Name: Larchwood Inns / Final Plan and Minor Plan and Subdivision-NW 15th & Patterson

TITLE HEADING: Final Plat - Minor Subdivision; Final
Plan Lot 2 - Larchwood Inns

Response to Review Comments
re: City of Grand Junction Planning Department File No. 93-93

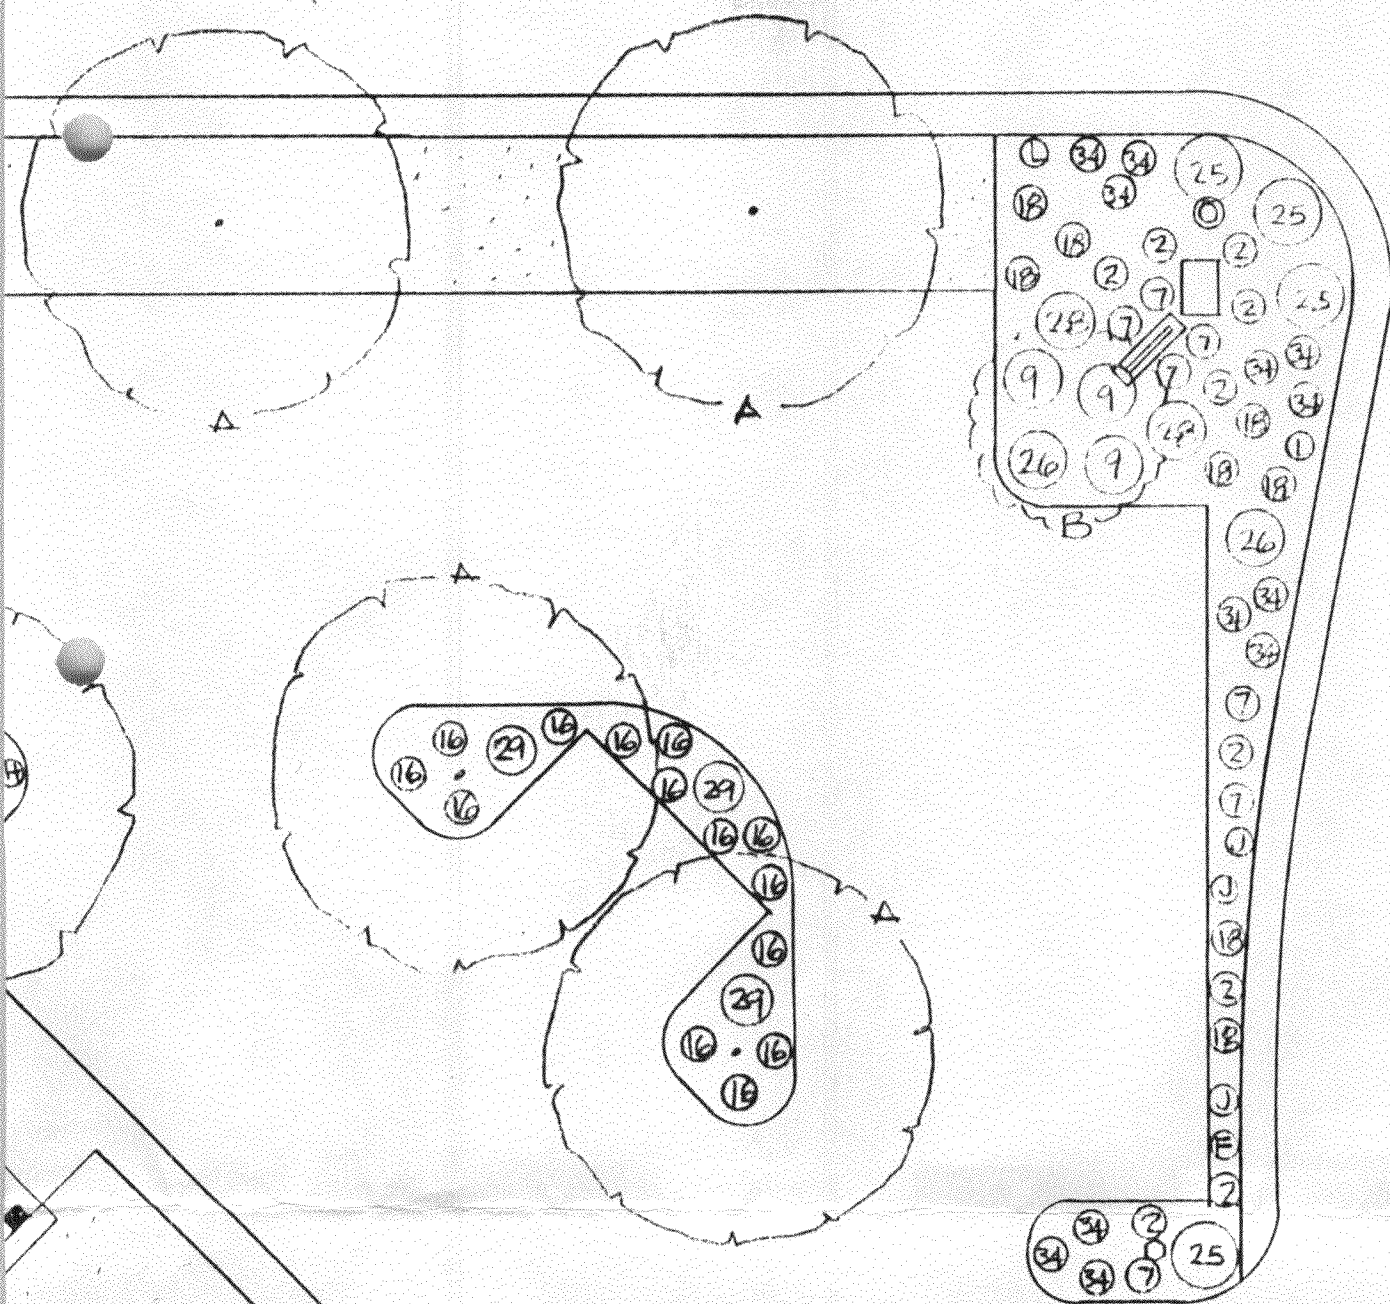
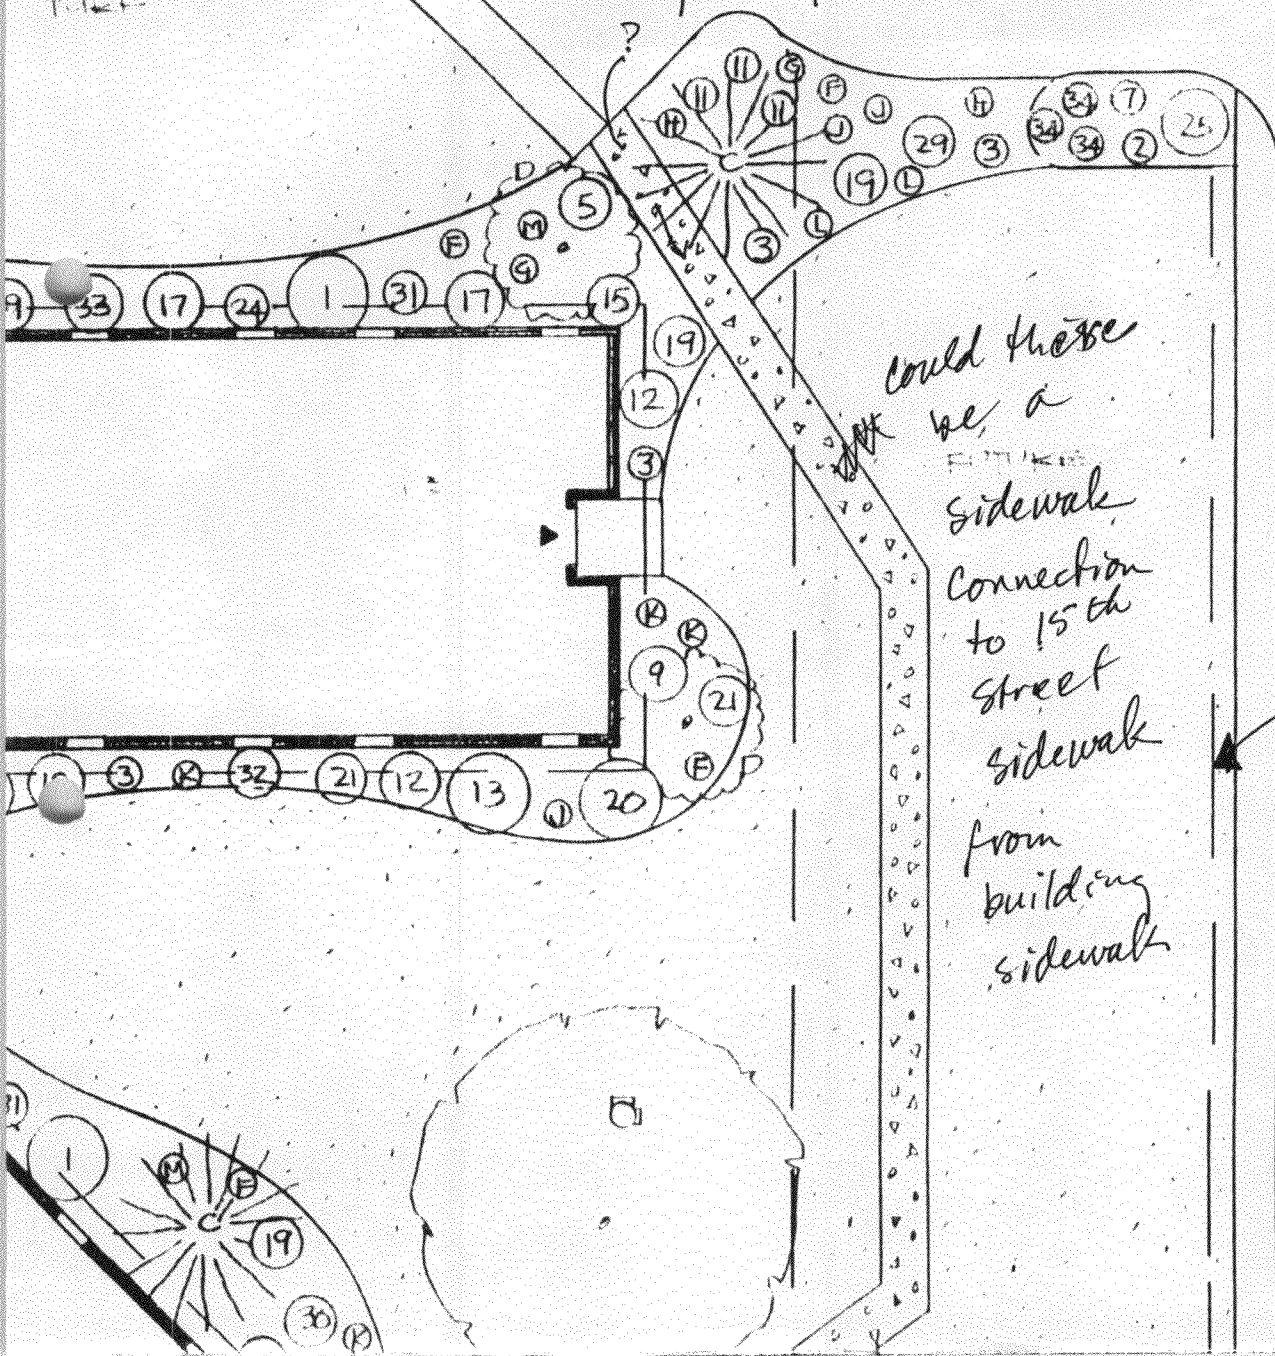
from building to public sidewalks
wheelchair accessible?

It seems problematic to have
go thru parking lot to

ks
 problematic to have to
 parking lot to sidewalk

Does this drain
 parking lot?

could these
 be a
 sidewalk
 connection
 to 15th
 street
 sidewalk
 from
 building
 sidewalk

Future
 Landscape?
